## BIG ROCK POINT PLANT

# AMENDMENT TO FACILITY OPERATING LICENSE

Amendment No. 10 License No. DPR-6

# ATTACHMENT TO LICENSE AMENDMENT NO. 10

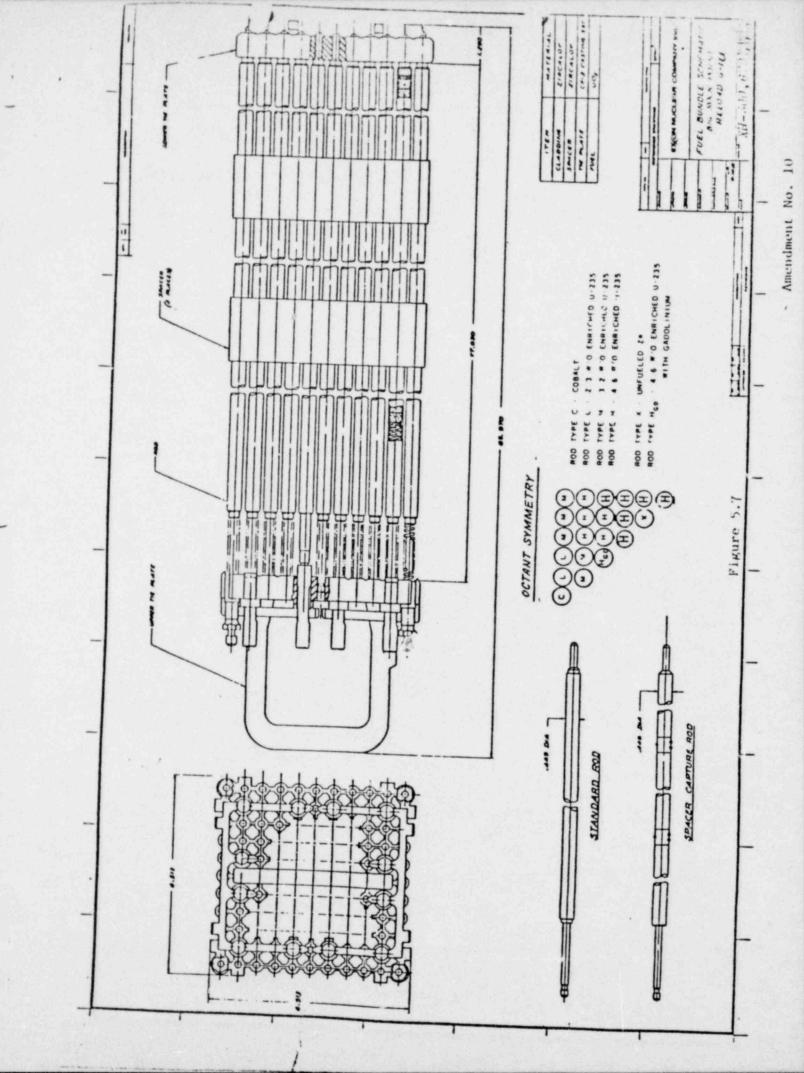
- Following the table in Section 5.2.1(b), add the attached Table 2 -MAPLHGR (kw/ft).
- Delete Figures 5.2 and 5.3 and renumber existing Figures 5.4 through 5.8 as 5.2 through 5.6, respectively. Add new Figure 5.7 attached.
- 15. Delete Section 6.1.4(a) in its entirety.
- 16. Delete Section 6.1.4(b) in its entirety.
- 17. Delete Section 6.1.4(c) in its entirety.
- 18. Change Section 6.1.5(b) to read as follows:
